Addendum 128 – Regulation No. 129

Amendment 5

01 series of amendments – Date of entry into force: 9 February 2017

Uniform provisions concerning the approval of Enhanced Child Restraint Systems used on board of motor vehicles

Top View – Bench with ISOFIX anchorages (Tolerance general: ± 2 mm)

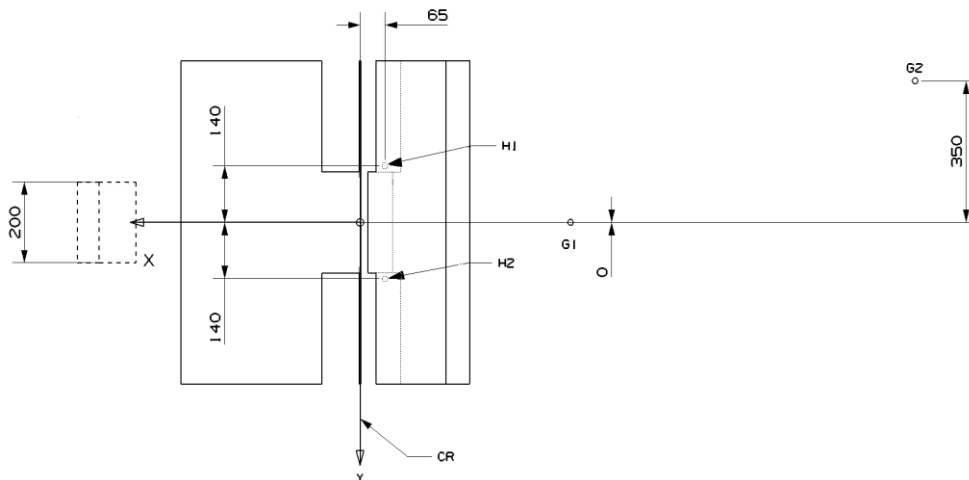
Appendix 2, amend to read:

1. The anchorages shall be positioned as shown in the figure below.
2. Enhanced Child Restraint Systems in the i-Size universal, specific and restricted categories shall use the following anchorage points: H1 and H2.

Figure 1
Door panel geometry and position at T0 – Top view

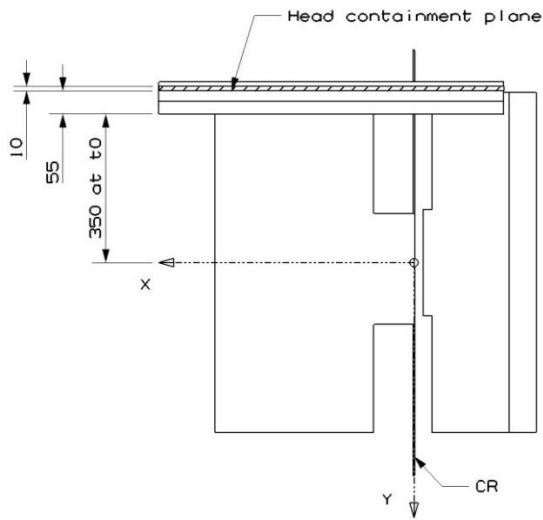
Appendix 3, amend to read:

Figure 4
Corridor for the padding material

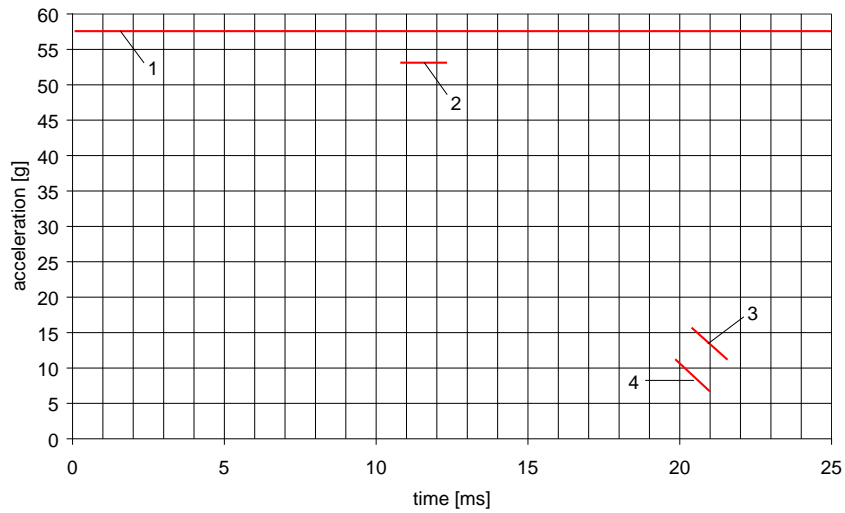
The impact surface of the door panel shall be entirely covered with a padding material of 55 mm in thickness (see Figure 1 above). The material shall comply with the performance criteria specified in paragraph 2.3. (Figure 4 below) of this appendix when tested in accordance with paragraph 2.2. of this appendix.

The impactor acceleration shall not exceed 58 g.

Appendix 1, the figure, amend to read:

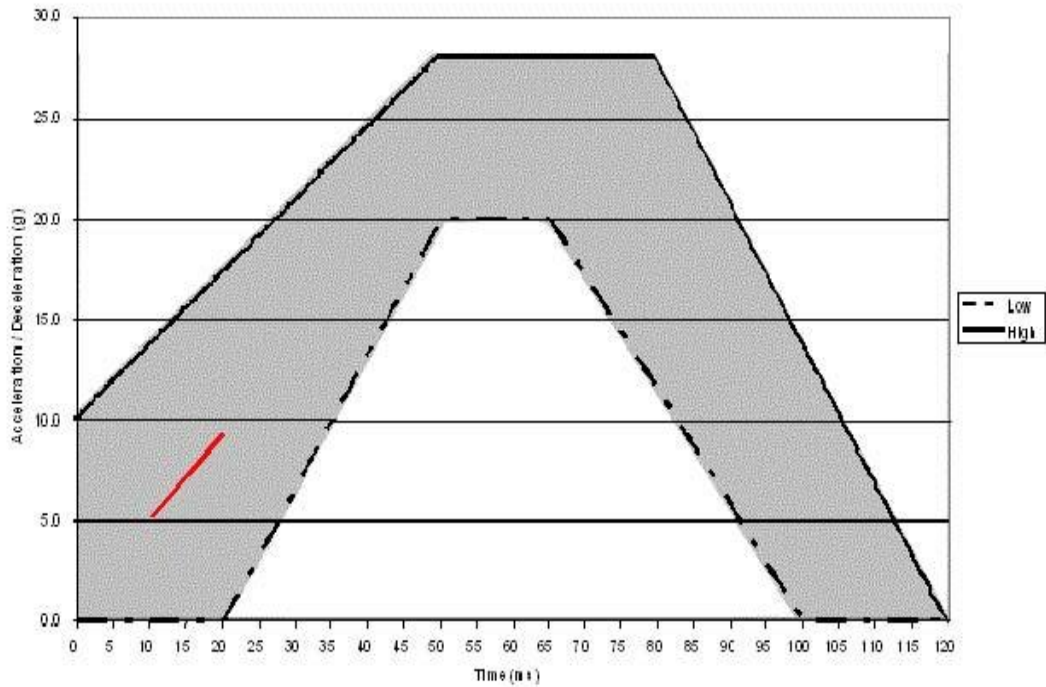
Annex 7,
